MPE720 Ver.7.92 version upgrade information

1.1 Ver.7.92 version upgrade information

The following are the items to add or improve MPE720 Ver.7.86→ Ver.7.92 functions.

No. 2 The newly added controller is supported by the project conversion function.

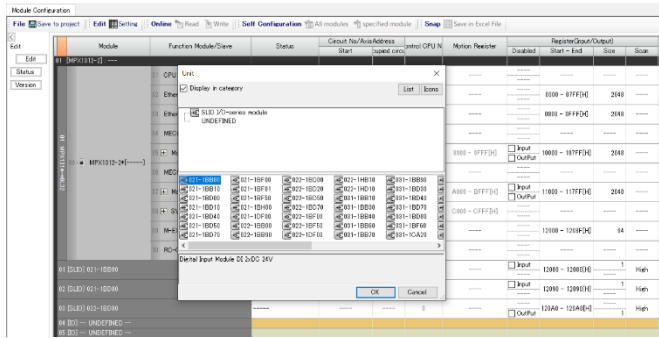
The conversion rules in the table below allow project conversion to a newly added controller.

[Conversion Rule]

Converter series: Model	Conversion destination controller
YRM-X::CPU-01	CPU-12 MPX1312-2
MP3000	CPU-12 MPX1312-2
Sigma-7C	CPU-12 MPX1312-2

No. 3 Compatible with SLIO I/O Series.

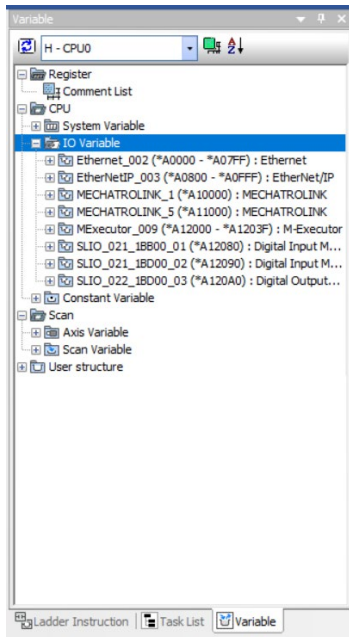
2)Parameters can be set for SLIO I/O series.

3)With the assignment of SLIO I/O series, SLIO informations is added to the input/output data.

No.4 SLIO M-4 bus coupler is supported.

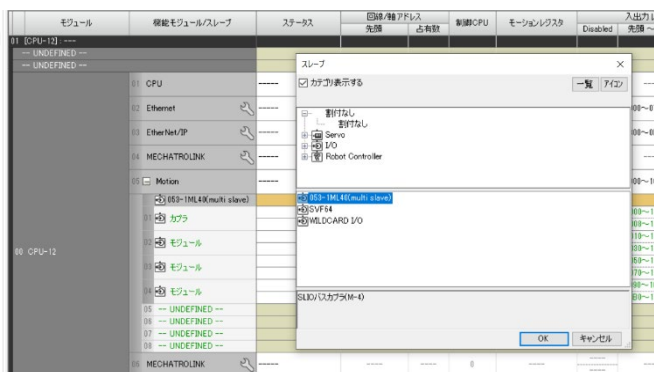
A SLIO M-4 bus coupler was supported as a MECHATROLINK-4 slave..

No.5 Regarding the Equipment configuration definitions, scan information was added to the Equipment I/F setting for multi-scan models.

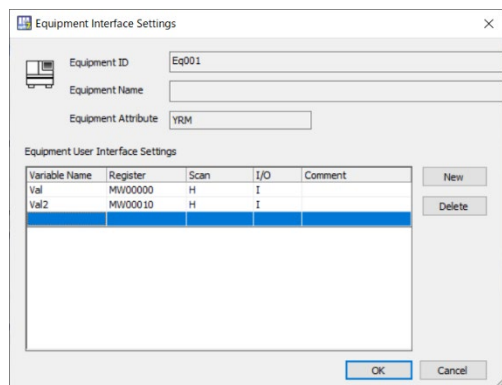
For multi-scan models and YRM controllers, the scan information is displayed in the Equipment I/F setting of the Equipment configuration definitions.

No.6 For the data sharing setting function, scan information was added for the multi-scan model.

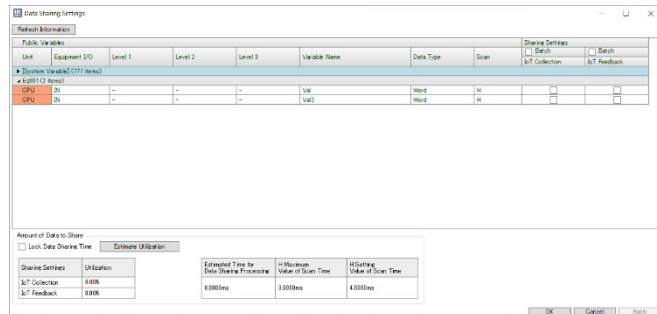
1) Scan information was added on the data sharing settings screen.

2) For the feedback setting of the data sharing setting, a constraint that prevents feedback is added when the register is selected as the copy destination register in the register mapping setting.

No.7 YNX controllers are supported in the Equipment configuration definition function.

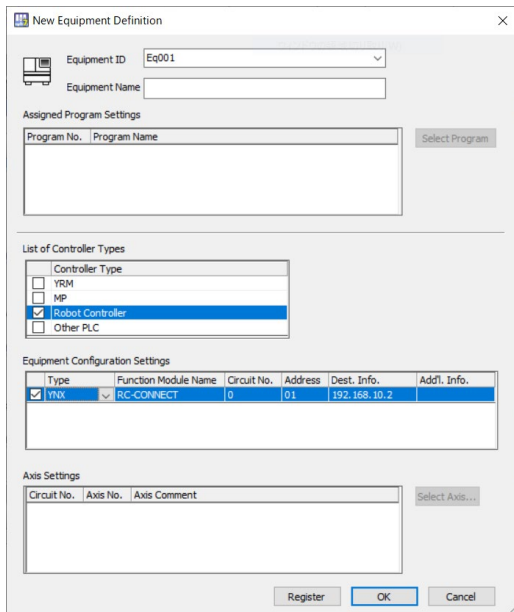
YNX controllers can be selected in the Equipment configuration definition function.

【About compile of the parallel circuit】

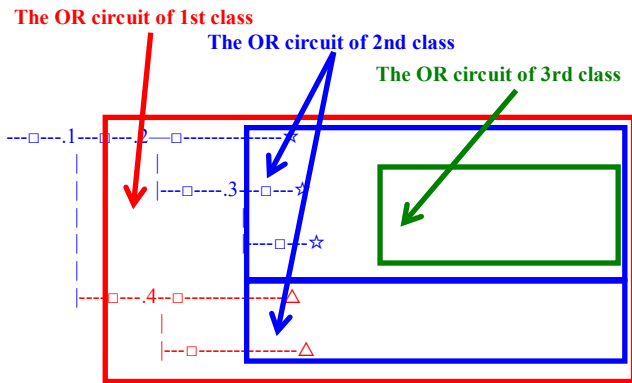
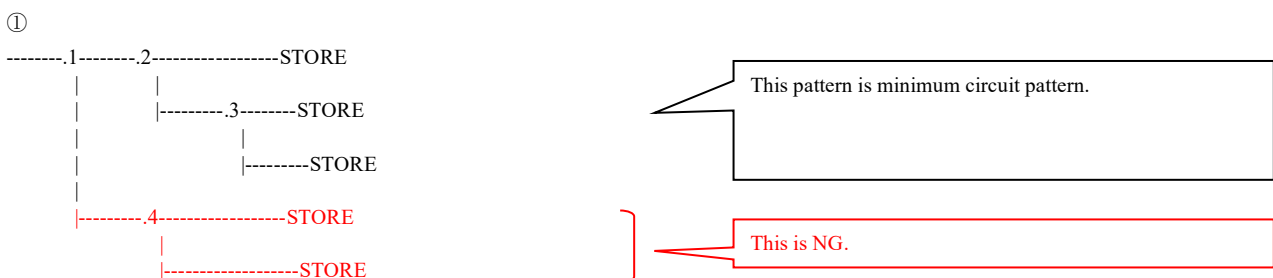
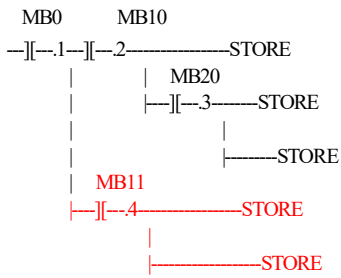
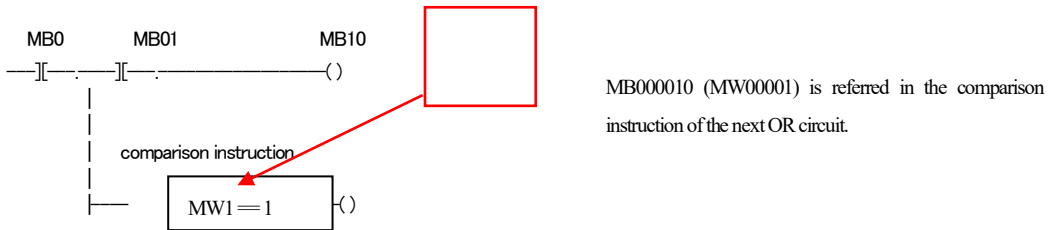
In the Ladder program of MPE720 Ver7 before MPE720 Ver7.23, when the parallel circuit is used, the following phenomena may occur.

When the circuit containing the following pattern was created, there was a phenomenon of operating without receiving the condition that the circuit below the OR circuit of 1st class must operate essentially in response to the conditional instruction before the OR circuit of 1st class.

It is NG even if the minimum circuit pattern has conditional instructions (NO Contact etc.).

It is NG when there are at least one block commands (STORE command etc.) here.

When a phenomenon occurs, please carry out re-compile about the Ladder program in MPE720 Ver7 after MPE720 Ver7.24. Or please carry out again “Compile All Programs” of “Compile” menu.
